BCA ASSESSMENT REPORT

Oakdale East, Horsley Park

Client: Goodman Property Services

Revision 2

Figure 1 – Areas of Non-Compliant Perimeter Vehicular Access per BCA C2.4.

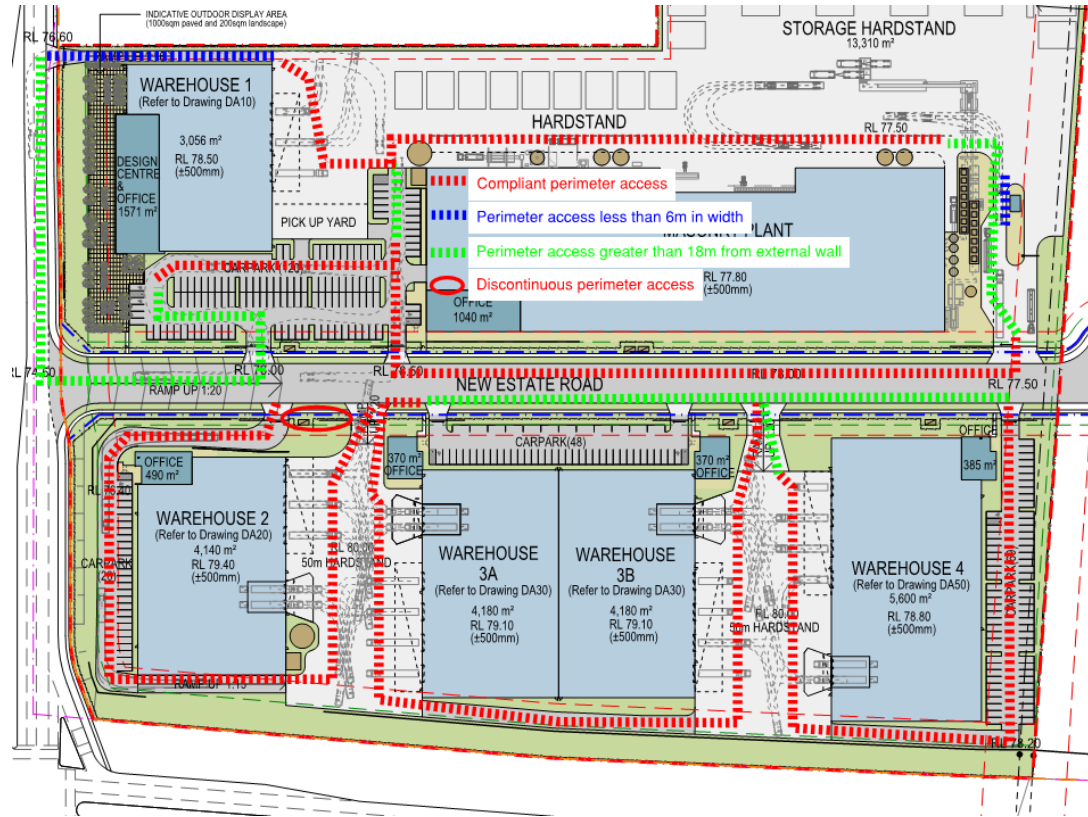
Comments: The proposed buildings do not comply with the provisions of C2.4 and thus the following non-compliance issues are required to be addressed as a Performance Solution by the Fire Engineer to demonstrate compliance with Performance Requirement CP9.

Vehicular Access is provided around all of the four (4) sides of all of the proposed buildings, however it is located greater than 18m from the external walls of Buildings 1, 3, 4 & the Masonry Plant, is discontinuous in the corners of Buildings 2 & 3, and is less than 6m in width along one side of Building 1 and the Masonry Plant – refer to diagram below:
